## SYDNEY CENTRAL CITY PLANNING PANEL COUNCIL ASSESSMENT REPORT

<b>Panel Reference</b>	PPSSCC-467
<b>DA Number</b>	DA/344/2023
<b>LGA</b>	City of Parramatta
<b>Proposed Development</b>	Demolition, tree removal and construction of 2 residential flat buildings over basement car parking with associated site and landscaping works. The application is Nominated Integrated Development pursuant to the Water Management Act 2000.
<b>Street Address</b>	85-91 Thomas Street, Parramatta, NSW 2150
<b>Applicant</b>	Century 888 Pty Ltd
<b>Owner</b>	Century 888 Pty Ltd
<b>Date of DA lodgement</b>	15 June 2023
<b>Date of Amendment of DA</b>	28 May 2024
<b>Number of Submissions</b>	An overall total of three (3) unique submissions during three (3) separate notification periods.
<b>Recommendation</b>	Approval
<b>Regional Development Criteria</b>	Development with a capital investment value of more than \$30 million. (\$30,455,751.00)
<b>List of all relevant s4.15(1)(a) matters</b>	<ul style="list-style-type: none"> <li>• Environmental Planning and Assessment Act 1979</li> <li>• Environmental Planning and Assessment Regulation 2021</li> <li>• State Environmental Planning Policy (Housing) 2021</li> <li>•

**Figure 1: Original Height Plane Analysis – Revision D**

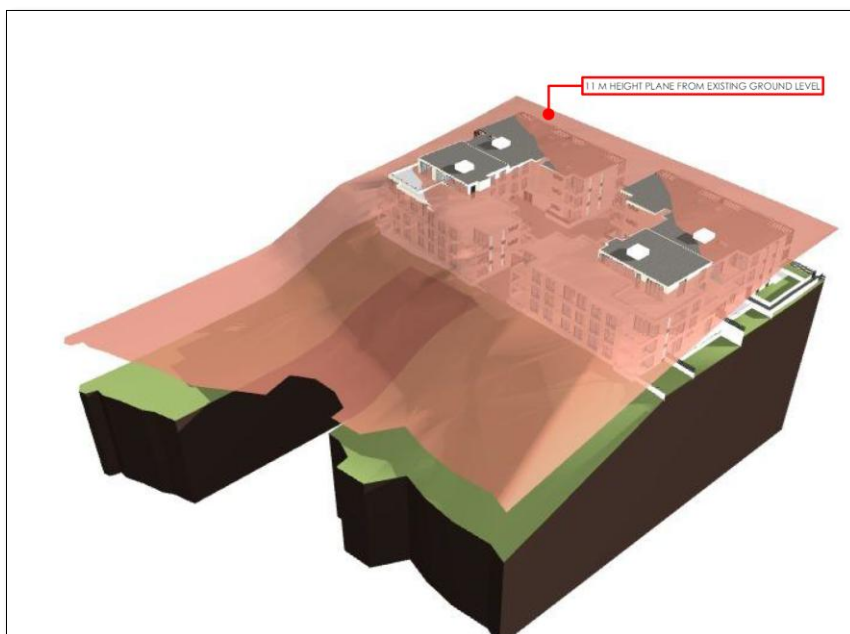
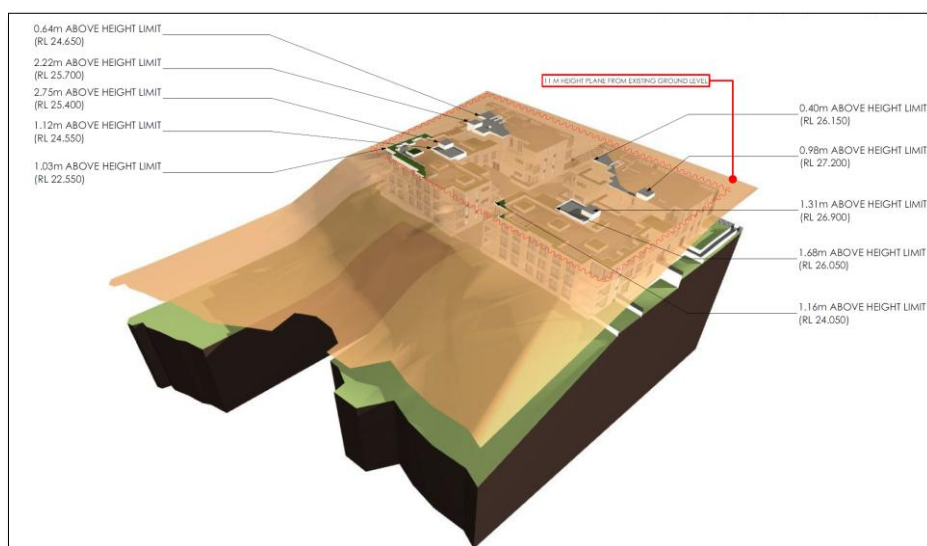
The original proposal did not comply with the maximum 11m building height development standard detailed in Clause 4.3 of the Parramatta LEP 2023. The proposed eastern building had a maximum height of 13.85m, and the western building had a maximum height of 14.45m. This equated to a 2.85m (25.9%) variation to the numerical height standard of 11m for the eastern building, and a 3.45m (31.36%) variation to the western building. The variation to the standard

related to portions of the 4th storey element, roof parapet, and lift overruns. It is noted that the height variation was supported as part of the original assessment.

The amended proposal has reduced the overall height with the eastern building comprising a maximum height of 12.68m, and the western building comprising a maximum height of 13.75m. This equates to a 1.68m (15.3%) variation to the numerical height standard of 11m for the eastern building, and a 2.75m (25%) variation to the western building. The variation to the standard relates to elements of the 3 storey, roof parapet, and lift overruns. The height of the eastern building has been reduced by 1.17m whilst the western building has been reduced by 0.7m.
